**Report: Pre-TAB Report**  
**Function: Test, Adjust, & Balance**  
**Date: 03/03/2026**  
**Completed By: National TAB**

## 03-23-26 WAWA #8245 YEAGERTOWN, PA

**WAWA #8245 Yeagertown PRE-TAB Inspection**

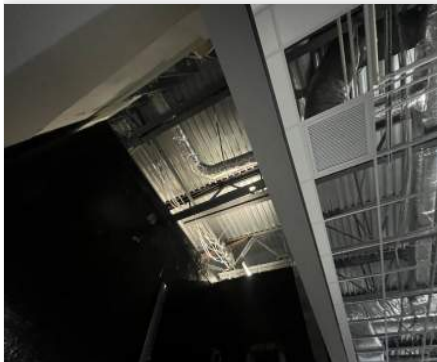
**Issue Name :** 2. Transfer Duct- Vestibule  
**Description :** Transfer duct for the vestibule is installed as an 8" but is designed as a 10". Upsize the duct.  
**Created By :** National TAB                      **Assigned To :** National TAB - Tyler Youells  
**Status :** Open  
**Priority :** Medium                                      **Asset Tag :**  
**Originated Date :** 03/03/2026 - Tyler Youells - National TAB

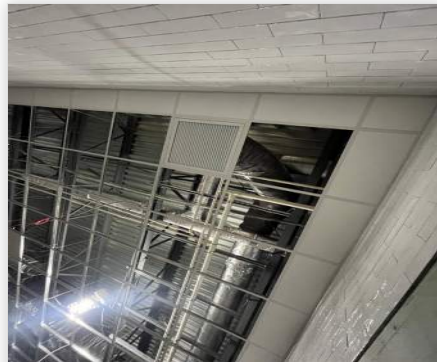
**Issue Name :** 3. RTU-3 Return Grille location  
**Description :** Relocate Return grille to ice chest and ice cream cooler alcove ceiling once the grid is installed.  
**Created By :** National TAB                      **Assigned To :** National TAB - Tyler Youells  
**Status :** Open  
**Priority :** **Medium**                                      **Asset Tag :**  
**Originated Date :** 03/03/2026 - Tyler Youells - National TAB

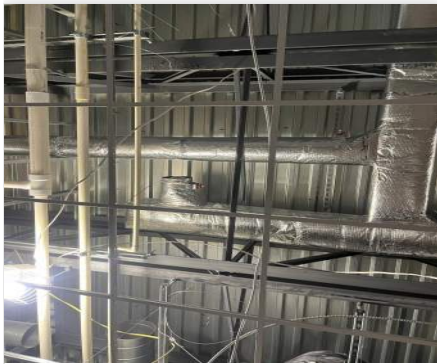
**Issue Name :** 5. Adjust Flexible duct- RTU-3 Return  
**Description :** Adjust the Flexible duct for RTU-3 return, Also recommend adjusting the plumbing support bracket to allow a better flex connection that is less impeded.  
**Created By :** National TAB                      **Assigned To :** National TAB - Tyler Youells  
**Status :** Open  
**Priority :** Medium                                      **Asset Tag :**  
**Originated Date :** 03/03/2026 - Tyler Youells - National TAB

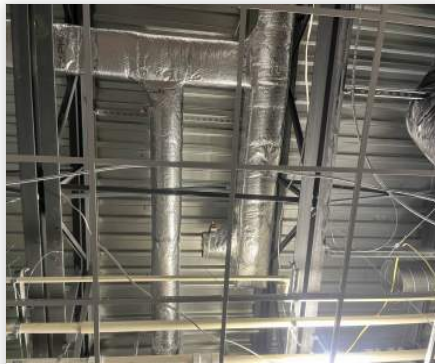
**Issue Name :** 6. Relocate supply takeoff- Delivery RM  
**Description :** Relocate the supply takeoff for the delivery room, current location will cause a tight duct connection. relocate to other side of the supply trunk and routing through Truss gap.  
**Created By :** National TAB                      **Assigned To :** National TAB - Tyler Youells  
**Status :** Open  
**Priority :** High                                      **Asset Tag :**  
**Originated Date :** 03/03/2026 - Tyler Youells - National TAB

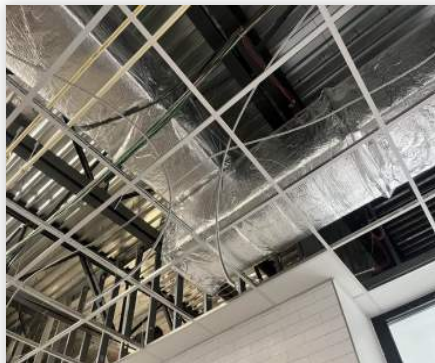
**Issue Name :** 17. Keynote 9 Transition  
**Description :** Info only: Keynote 9 transition has caused problems with TAB for a couple other WAWA locations, believe turbulence is causing restriction that has to be overcome with speeding the unit up and increasing overall system pressure. Recommend EOR review.  
**Created By :** National TAB                      **Assigned To :** National TAB - Tyler Youells  
**Status :** Open  
**Priority :** InfoOnly                                      **Asset Tag :**  
**Originated Date :** 03/04/2026 - Tyler Youells - National TAB

HVAC FLOOR PLAN  
1/4" = 1'-0"

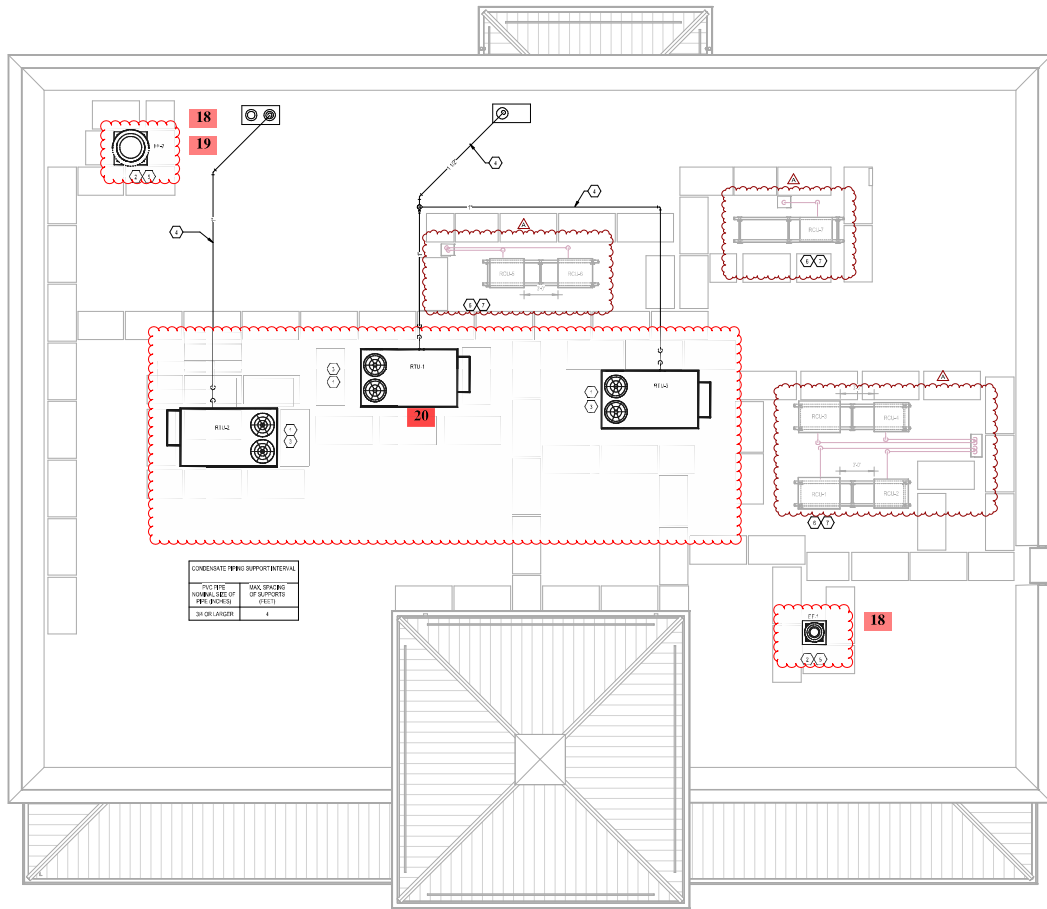
1. Damper is not installed
2. Transfer duct is not sized correctly Installed as 8", supposed to be 10"
3. Return Grille not correctly located, Is installed in retail ceiling grid needs to be in the ice chest ceiling grid

4. Stuck damper handle, only closes halfway
5. Flex duct is pinched on plumbing support, tidy up the insulation
6. Relocate start collar to the other side of the duct to prevent duct interference and pinching

7. Multiple cases, long radius elbows were substituted for 90 Mitered elbows with turning vanes
8. Elbow and damper not yet installed for exhaust grille

9. Flip orientation of the linear diffuser for proper duct connection
10. Duct drop is not a plenum drop and has a radiused elbow, seek engineer approval and or recommendation to repair

11. Recommend reviewing and adjusting, Diffuser takeoff is not oriented the proper direction to connect to the linear diffuser, Plumbing is a major obstruction preventing proper orientation.

12. Missing damper for return grille
13. Return grille flex duct is excessive and needs to utilize more hard duct and flex needs to be better supported
14. Start collar orientation is opposite of directional airflow (transition is not properly oriented) correct orientation and adjust damper position so it is still accessible.

15. Start collar and duct is not installed, per MC they are trying to takeoff from the bottom of the supply trunk due to obstructions, Seek approval from engineer or recommendation for alternate solution.

16. Duct takeoff is located further up on the main trunkline to avoid structure, Note only
17. Note only, Keynote 9 has been done per prints, from experience at past wawa locations we have had a hard time getting airflow through the transition seemingly from turbulence causing higher Unit static pressure.
